BRUSHWELLMAN
ENGINEERED MATERIALS

Delivered herewith are four (4) copies of a DRAFT version of Brush's Revised Reclamation Plan previously submitted on January 12, 1987. Please note that all changes are made in bold type. The DRAFT version contains Brush's technical response to DOGM's staff comments contained in your letter of March 30, 1987. The DRAFT version also contains other changes in the Revised Reclamation Plan as we agreed during our May 18, meeting with you and your staff.

CROSS REFERENCE LIST FOR
DOGM, MARCH 30, 1987 STAFF COMMENTS AND
BRUSH WELLMAN'S JUNE 12, 1987 TECHNICAL RESPONSE
AS CONTAINED IN THE DRAFT VERSION OF
BRUSH'S REVISED RECLAMATION PLAN

MINING AND RECLAMATION PLAN REVIEW
Brush Wellman, Inc.
Topaz Mining Property
ACT/023/003
Juab County, Utah

Figure 4.3-1
Topsoiled Dumps with Tuff-Covered Top

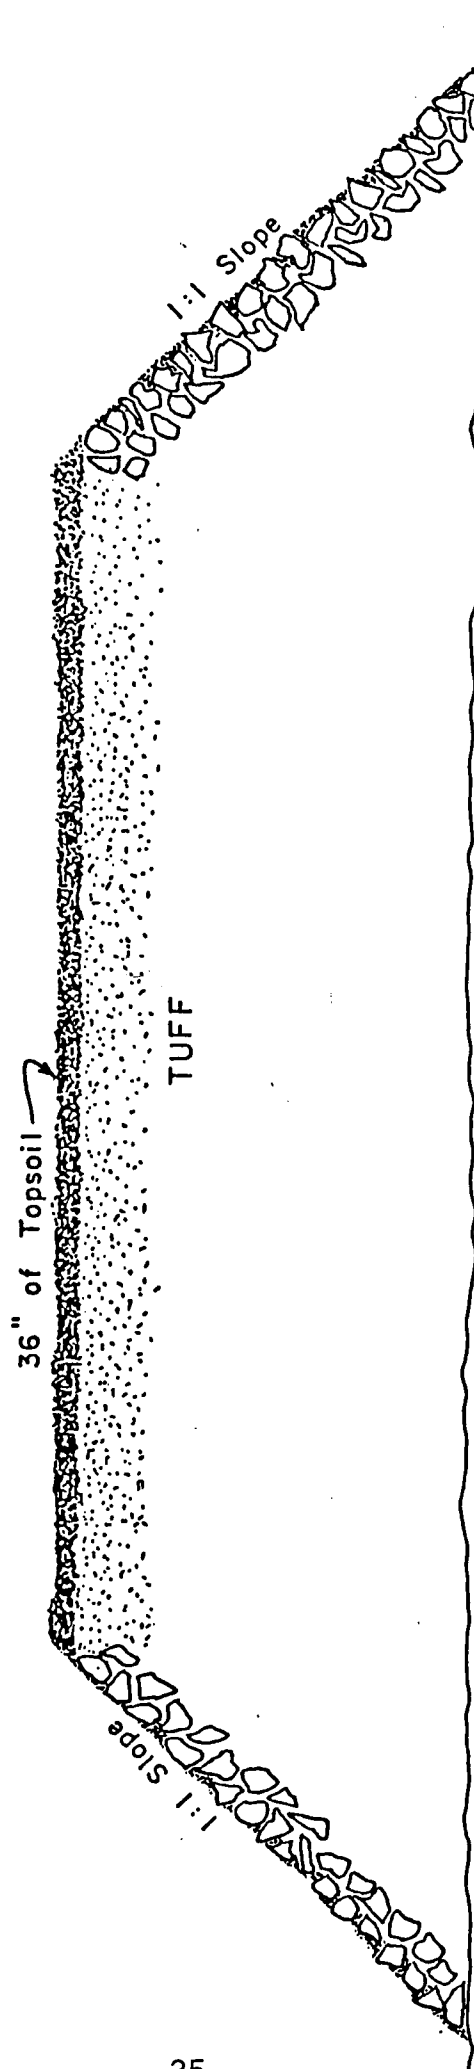
The configuration of the slopes shown in the reclamation plan are such that the ridge lines of the waste piles are emphasized rather than rounded in order to blend in with the surrounding terrain. The operator has indicated that these ridges are intended to remain in order to affect suitable erosion control of the dumps. Stability analysis provided by the operator is based on past performance and operating procedures as approved by MSHA. The
